UNITED STATES PATENT AND TRADEMARK OFFICE

Office Action Summary

10/733,124

DETAILED ACTION

FIGURE A

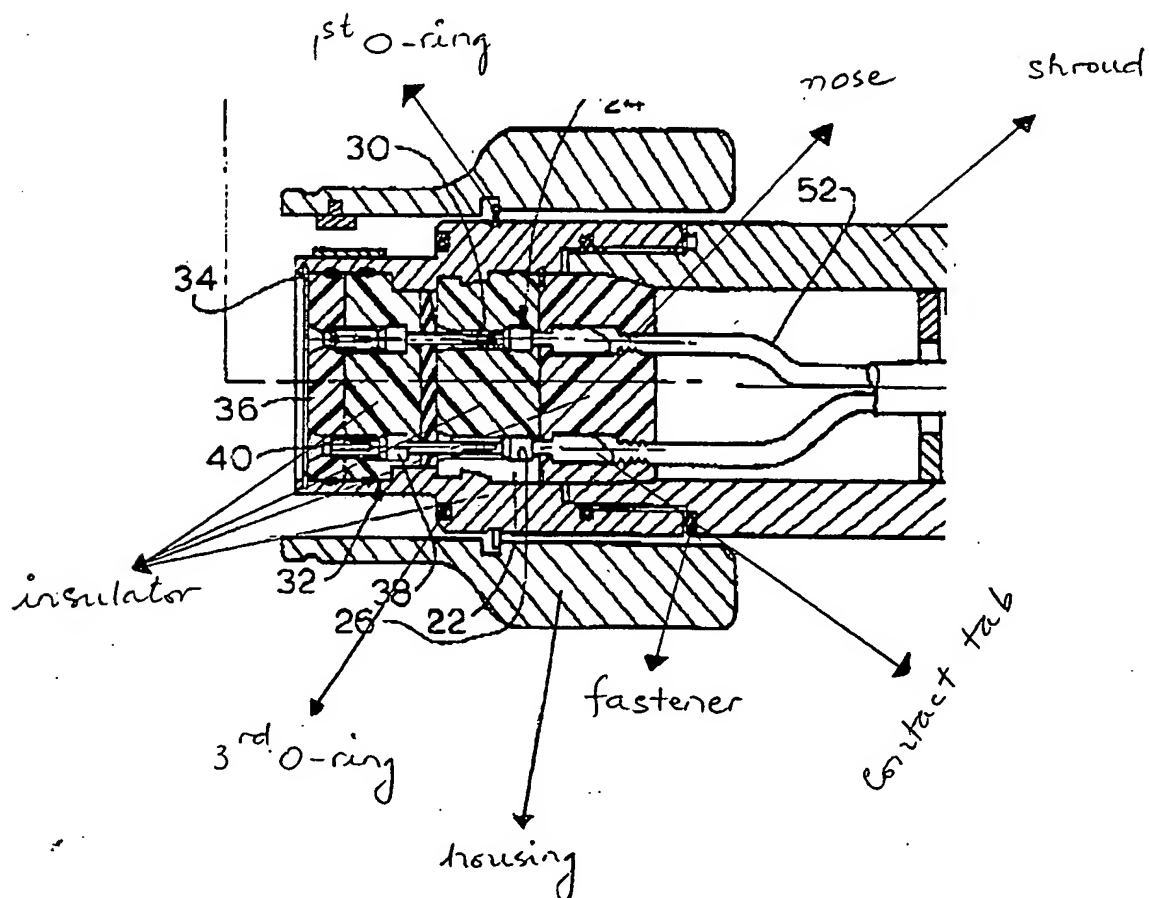
Regarding claim 4, Gerow, figure 2 shows a pressure-tight contact device for enabling an electrical connection to an electrical device housed in a pressure-tight housing, the contact device comprising an insulator (a FIGURE A below) extending through said housing (the FIGURE A below), at least one contact pin (38) extending through the insulator, a first O-ring seal (the FIGURE A below) for sealing the insulator relative to the housing, a connector shell (20) of insulating material positioned on the insulator and affixed to the insulator, the connector shell including a shroud (the FIGURE A below) and a terminal socket (not labeled) for receiving a connecting cable (50), at least one contact tab (30, 24 and the FIGURE A below) mounted in the connector shell, the at least one contact pin elastically and electrically connected to the at least one contact tab, a third O-ring seal (the FIGURE A below) for sealing the connector shell relative to the insulator, and at least one fastener (the FIGURE A below)

for affixing the connector shell to the insulator, the at least one contact tab and the shroud forming the terminal socket for mating with a connector member of the connecting cable.

Gerow discloses the claimed invention as described above except for a second O-ring seal for sealing the at least one contact pin relative to the insulator.

Regarding claim 5, Gerow shows the contact pin including at least one tip arranged and constructed to engage at least one opening (a front end of 30) defined in the contact tab.

Regarding claim 6, the at least one contact tab including at least one contact face (a front end of the opening) defined by the at least one opening, the at least one contact face bearing against the at least one contact pin to provide an electrical connection between the contact pin and the contact tab.

Regarding claim 7, Gerow shows the at least one contact pin and the contact tab are positioned proximate one another.

Regarding claim 8, Gerow shows nose member (the FIGURE A below) for positioning the contact tab in the connector shell (since 24 is a crimp terminal).
